Access Compliance Report

Public Rights-of-Way

(Curb Ramps)

Intersection ID: 44110	Main Street: GLENLUCE_AV	Cross Street: STAFFORDSHIRE_LN	Location: W
ADA ID: 2F31D99F6ED6	Ramp Type: PerpDiag	Initial Pass/Fail: Fail	Overall Compliance: No
Severity Score: 8.75			
Codes/Mitigation Info/Possible Solution		Field Measurements/Component Compliance

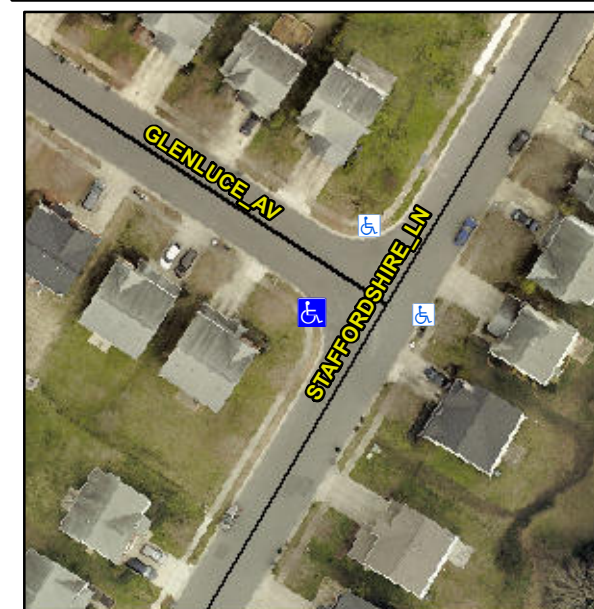
Not Found, R304.5.1

Compliance	Description	Data	Compliance	Description	Data
N/A	Ramp Length (in)	46.5	Yes	Ramp Slope (%)	8.0
No	Ramp Width (in)	47.5	Yes	Ramp XSlope (%)	1.1
N/A	Flare Type LT	N/A	N/A	Flare Type RT	N/A
N/A	Flare Slope LT (%)	N/A	N/A	Flare Slope RT (%)	N/A
N/A	Flare Traversable LT?	N/A	N/A	Flare Traversable RT?	N/A
N/A	Landing Length (in)	N/A	N/A	DWS Provided?	N/A
N/A	Landing Width (in)	N/A	N/A	DWS Contrast?	N/A
N/A	Landing Slope (%)	N/A	N/A	DWS Length (in)	N/A
N/A	Landing X Slope (%)	N/A	N/A	DWS Full Width?	N/A
N/A	Landing Curb? (Y/N)	N/A	N/A	DWS Offset (in)	N/A
N/A	Shared Landing?	N/A			
N/A	Gutter Ponding?	N/A	N/A	Gutter Slope (%)	N/A
N/A	Gutter Lip Ht (in)	N/A	N/A	Gutter X Slope (%)	N/A
N/A	Painted X Walk1?	No	N/A	Painted X Walk2?	No
	X Walk 1 Direction	To SE		X Walk 2 Direction	To NE
N/A	X Walk 1 Width (in)	N/A	N/A	X Walk 2 Width (in)	N/A
	X Walk 1 Slope (%)	3.6		X Walk 2 Slope (%)	2.9
	X Walk 1 X Slope (%)	2.4		X Walk 2 X Slope (%)	2.3

Remove & Replace Curb Ramp With Two New Directional Ramps or Equivalent.
